AIR - H.P.C. BLEED AIR TUBES - REVISED CORE ENGINE TUBES TO IMPROVE CLEARANCE WITH HARNESS IN BIFURCATION AREA - R.H. SIDE - CATEGORY CODE 7 - MOD.ENG-75-0016

V2500-ENG-75-0016

SERVICE BULLETIN

Location of H.P. Compressor Bleed Air Tubes
Fig.1 (Sheet 1 of 2)

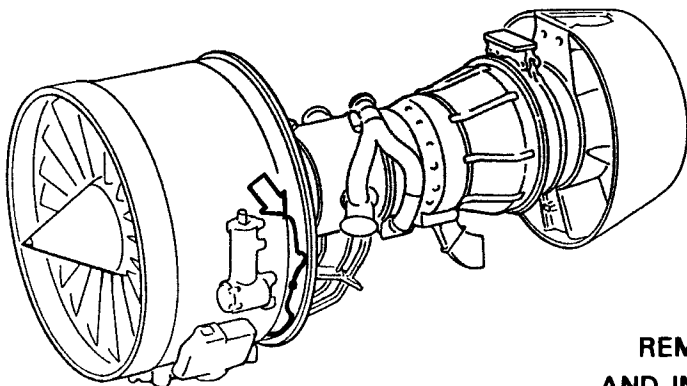
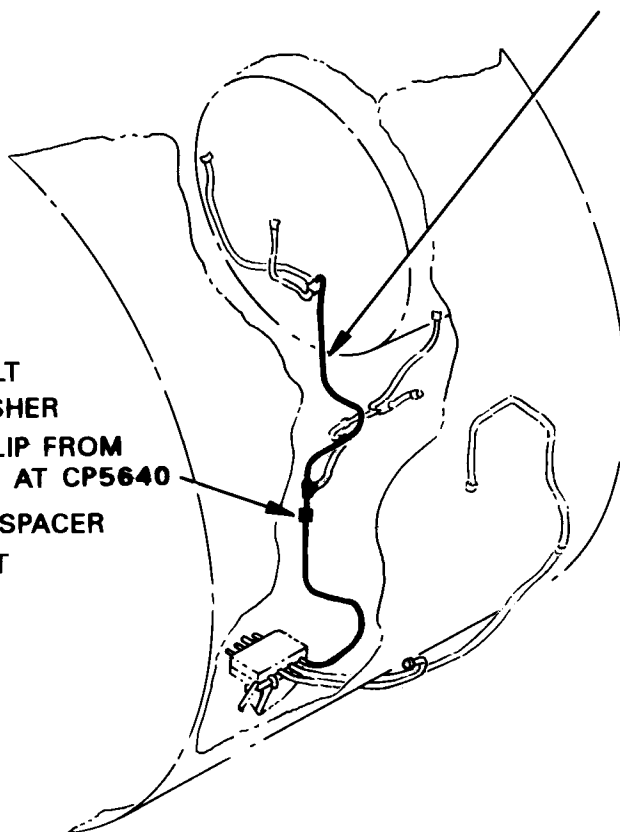
**REMOVE 740-5278-505 TUBE ASSY
AND INSTALL 740-5278-507 TUBE ASSY**

**REMOVE 4W0106 BOLT
REMOVE SP154D WASHER
REMOVE 400WSS4 CLIP FROM
CP5834 AND INSTALL AT CP5640
REMOVE ST1698D47 SPACER
REMOVE 4W0001 NUT**

Location of Fuel Drain Tubes (Before alteration)
Fig.2

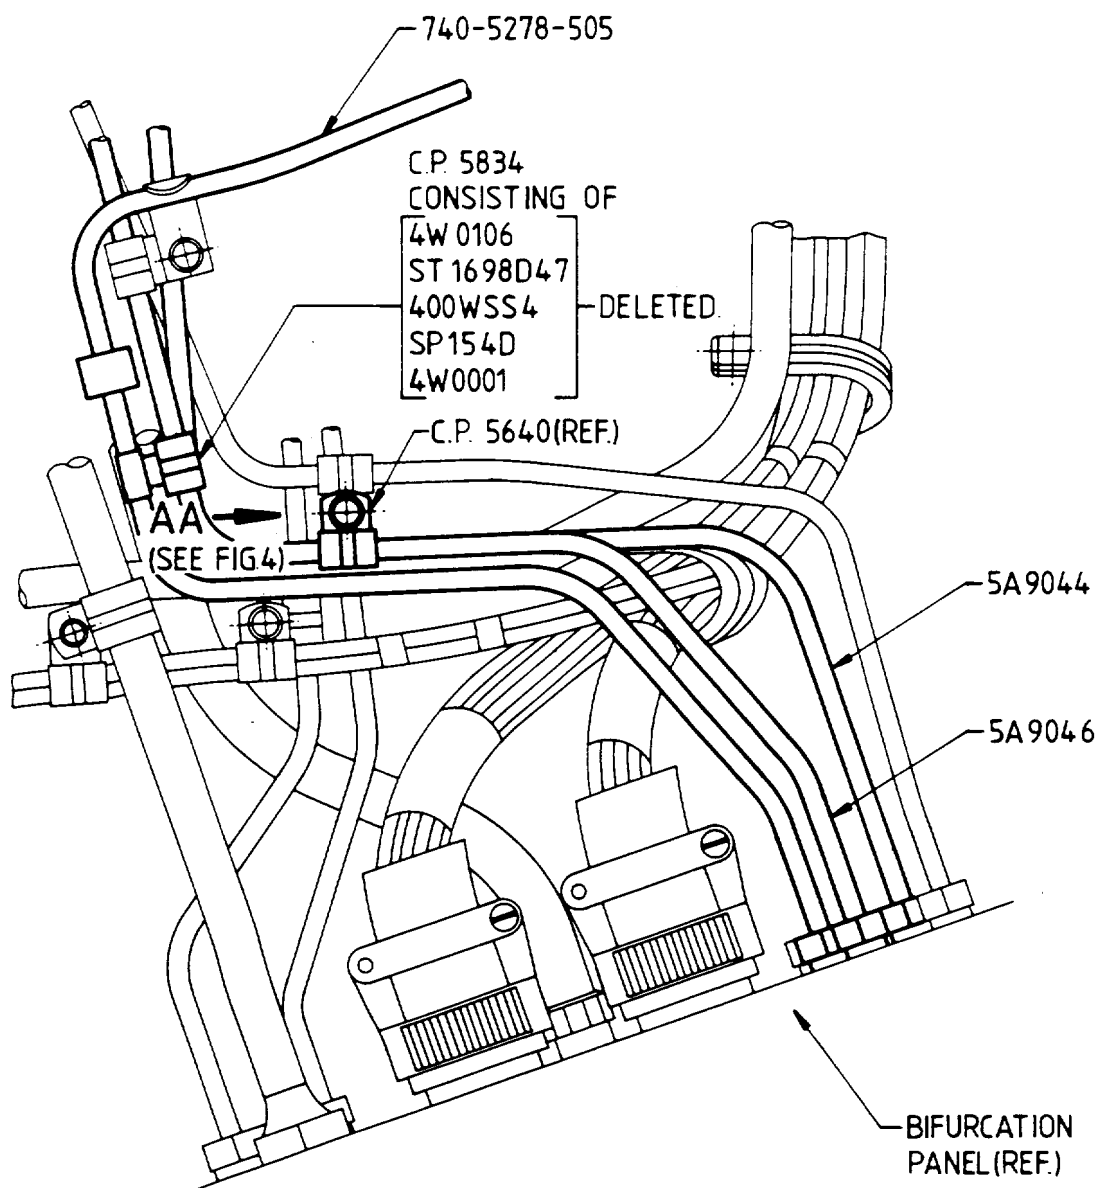
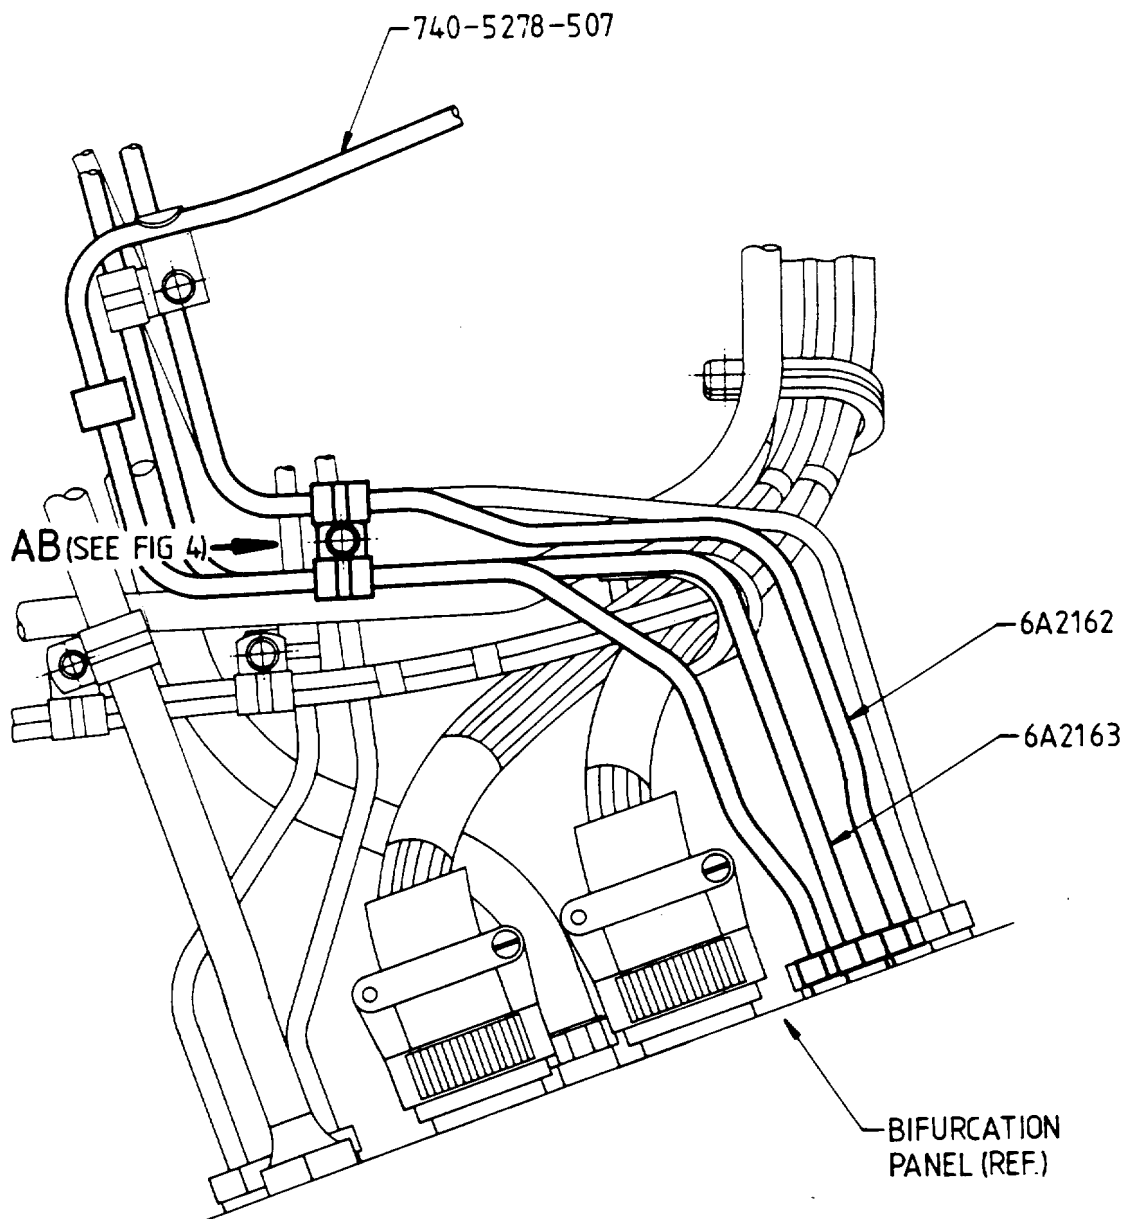
- (a) Two bleed valve air tubes and one servo fuel drain tube have been re-run to achieve an acceptable clearance between themselves and the core engine harness.
- (b) The original servo fuel tube clipping point 5834 is deleted.
- (c) Clipping point 5640 is amended to incorporate the re-run bleed valve air tubes and servo fuel drain tube. The existing clip at the now deleted clipping point 5834 is transferred to clipping point 5640 to clip re-run servo fuel drain tube.

- (1) Remove 740-5278-505 tube assembly drain (Figure 2).
 - (a) Remove bolts, washers, spacers and clips at clipping position 5833.
 - (b) Remove 4W0001 nut, SP154D washer, 400WSS4 clip, ST1698D47 spacer and the 4W0106 bolt from the 5834 clipping point.

- (1) Install the tube 740-5278-507 tube assembly drain (02-500).
 - (a) Connect 740-5278-507 to the ACC actuator and to 740-5688-509 at the bifurcation panel.

- (b) Connect 740-5278-507 to 740-5277-505 tube assembly drain (01-500).
 - (c) Connect 740-5278-507 to 740-5279-507 tube assembly drain (02-100).
 - (d) Torque the tube connectors (in steps (A), (B) and (C)) to 157 - 177 lbfin (18 - 20 Nm) and safety with CoMat 02-126 lockwire.

- (e) Install the clip, the washer and the bolt, at the clip position 5833. Torque the nut to 36 - 45 lbfin (4 - 5 Nm).
- (2) Install the 6A2162 tube air 7th B/VAL A/O (75-32-49, 13-100).

Clipping point 5640
Fig.4

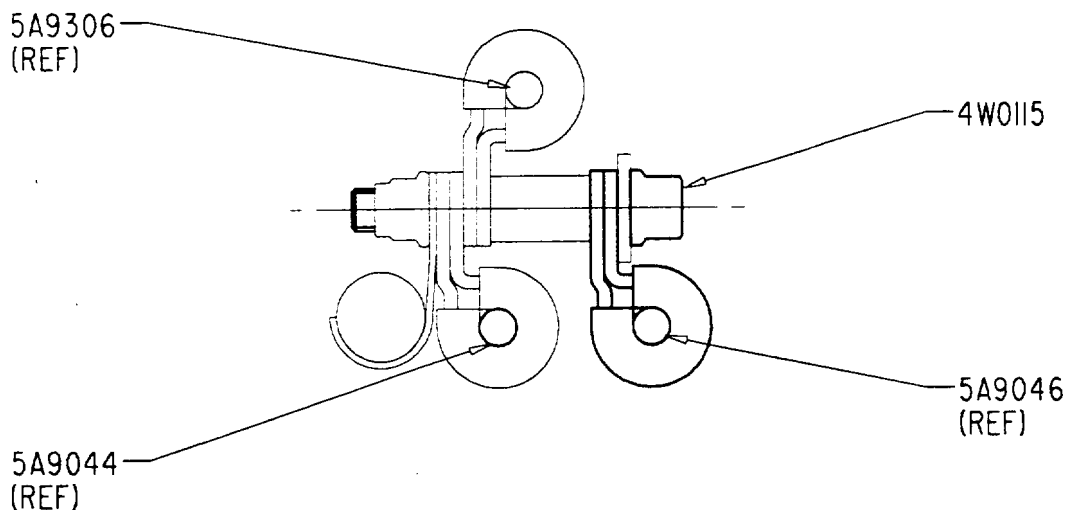
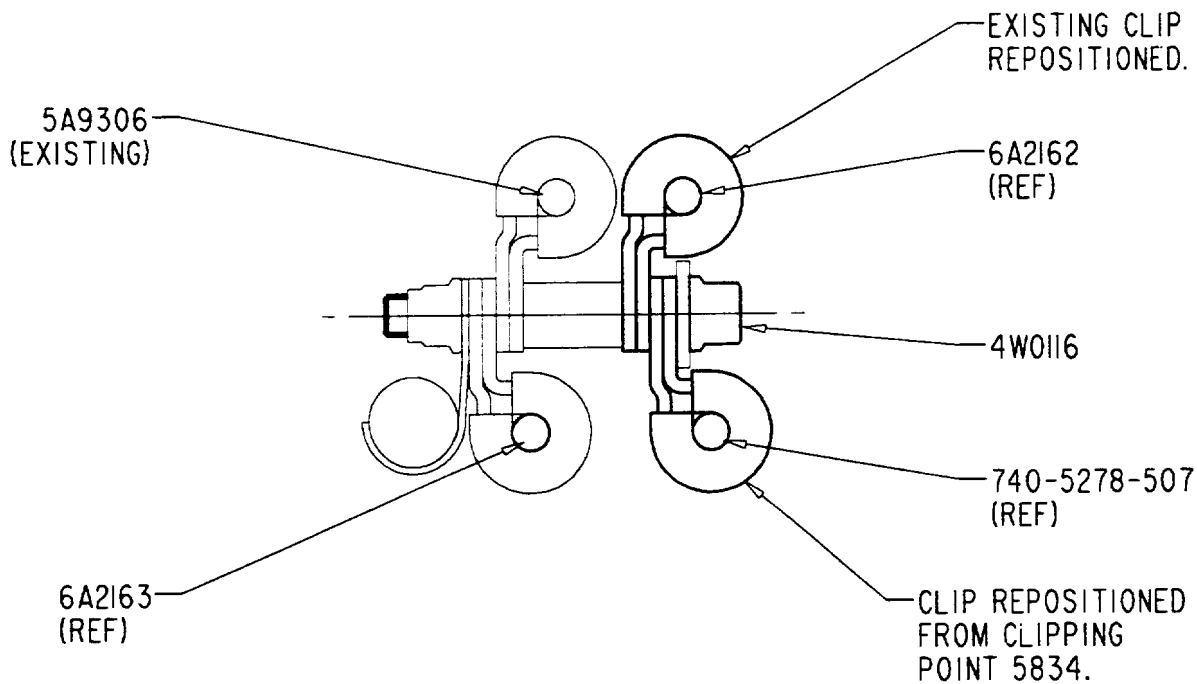
- (2) Remove 5A9044 tube air HPC 7th B.VAL A/O (75-32-49, 13-100).
 - (a) Remove the 4W0001 nut, the 6A2134 raceway, the 400WSS4 clip, the 5W1031 spacer, the 400WSS4 clip, the 5W1086 washer, and the 4W0115 bolt from the 5640 clipping point (refer to Figure 4).

- (b) Connect 6A2163 to 5A8755 tube A/O air (14-500).
 - (c) Install the 5640 clipping point, the 4W0116 bolt, the 5W1086 washer, the 1st 400WSS4 clip repositioned from clipping point 5834, the existing 400WSS4 clip repositioned, the 5W1031 spacer, the existing 400WSS4 clip, the 6A2134 raceway with the 40001 nut (refer to Figure 4), torque the nut to 36-45 lbf.in. (4-5 Nm).
